## Product Change Notice (PCN)

PCN Number: **PCN-0456180R-02**

Product(s) Affected: *PJ-041H*

PREVIOUS CUI DEVICES DETAIL / IMAGE	NEW CUI DEVICES DETAIL / IMAGE

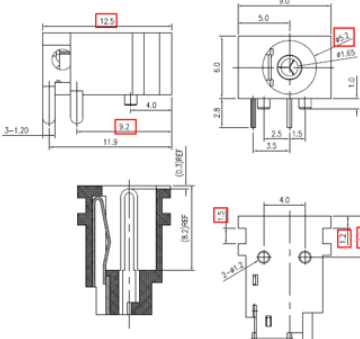
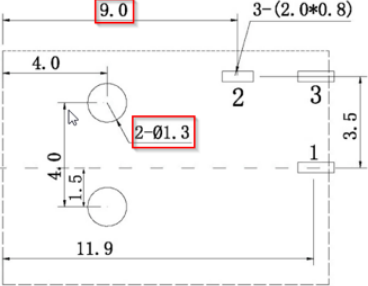
Description of Change: *New Factory Location. Product re-engineered for improved manufacturability and production yield. See image below for reference and check CUI Devices website for updated drawing. Cosmetic differences may be visible and not affect the form fit and function of the product.*

PREVIOUS CUI DEVICES DETAIL / IMAGE			NEW CUI DEVICES DETAIL / IMAGE		
DESCRIPTION	MATERIAL	PLATING/COLOR	DESCRIPTION	MATERIAL	PLATING/COLOR
center pin	brass	silver	center pin	copper alloy	silver
terminal 1	brass	silver	terminal 1	copper alloy	silver
terminal 2	C5191 phosphor bronze t=0.30	silver	terminal 2	copper alloy	silver
terminal 3	C5210 brass t=0.30	silver	terminal 3	copper alloy	silver
housing	PA66 (UL94V-0)	black	housing	PPA (UL94V-0)	black

<p>MATING PLUG Jack Insertion Depth <b>8.9 mm</b></p>	 <p>MATING PLUG Jack Insertion Depth <b>8.2 mm</b></p>
---	--
